## Access Compliance Report Public Rights-of-Way (Curb Ramps)

Intersection ID: 18127 Main Street: BRANDYWINE\_RD Cross Street: SELWYN\_AV Location: SW

ADA ID: D118B6CA17C0 Ramp Type: PerpDiag Initial Pass/Fail: Fail Overall Compliance: No Severity Score: 33.75

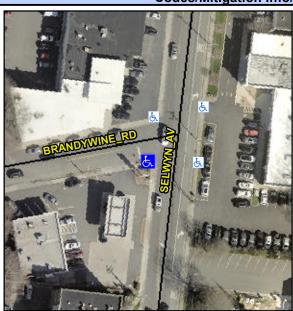
PROW/ADA:
Not Found, R304.5.1, R304.5.3

Field Measurements/Component Compliance					
Compliance Description		Data	Comp	liance Description	Data
N/A	Ramp Length (in)	65.0	Yes	Ramp Slope (%)	5.7
No	Ramp Width (in)	45.0	No	Ramp XSlope (%)	9.2
N/A	Flare Type LT	N/A	N/A	Flare Type RT	N/A
N/A	Flare Slope LT (%)	N/A	N/A	Flare Slope RT (%)	N/A
N/A	Flare Traversable LT?	N/A	N/A	Flare Traversable RT?	N/A
N/A	Landing Length (in)	N/A	N/A	DWS Provided?	N/A
N/A	Landing Width (in)	N/A	N/A	DWS Contrast?	N/A
N/A	Landing Slope (%)	N/A	N/A	DWS Length (in)	N/A
N/A	Landing X Slope (%)	N/A	N/A	DWS Full Width?	N/A
N/A	Landing Curb? (Y/N)	N/A	N/A	DWS Offset (in)	N/A
N/A	Shared Landing?	N/A			
N/A	Gutter Ponding?	N/A	N/A	Gutter Slope (%)	N/A
N/A	Gutter Lip Ht (in)	N/A	N/A	Gutter X Slope (%)	N/A
N/A	Painted X Walk1?	No	N/A	Painted X Walk2?	No
	X Walk 1 Direction	To E		X Walk 2 Direction	To N
N/A	X Walk 1 Width (in)	N/A	N/A	X Walk 2 Width (in)	N/A
	X Walk 1 Slope (%)	6.8		X Walk 2 Slope (%)	6.6

X Walk 1 X Slope (%)	3.7		X Walk 2 X Slope (%)	5.7
N/A	Ramp inside XWalk1?	N/A	N/A	Ramp inside XWalk2?	N/A
	Road Slope (%)	8.9	N/A	Clear Space?	N/A
	Road X Slope (%)	9.4	N/A	Clear Space to XWalk (in)	N/A
N/A	Any Obstructions?	N/A	N/A	Storm Grate/Utility Hazard?	N/A
	Obstruction Type			Storm Grate/Utility Type	
		N/A			N/A
			Yes	Surface Condition? (G/P)	Good

Remove & Replace Curb Ramp With
Two New Directional Ramps or
Equivalent.
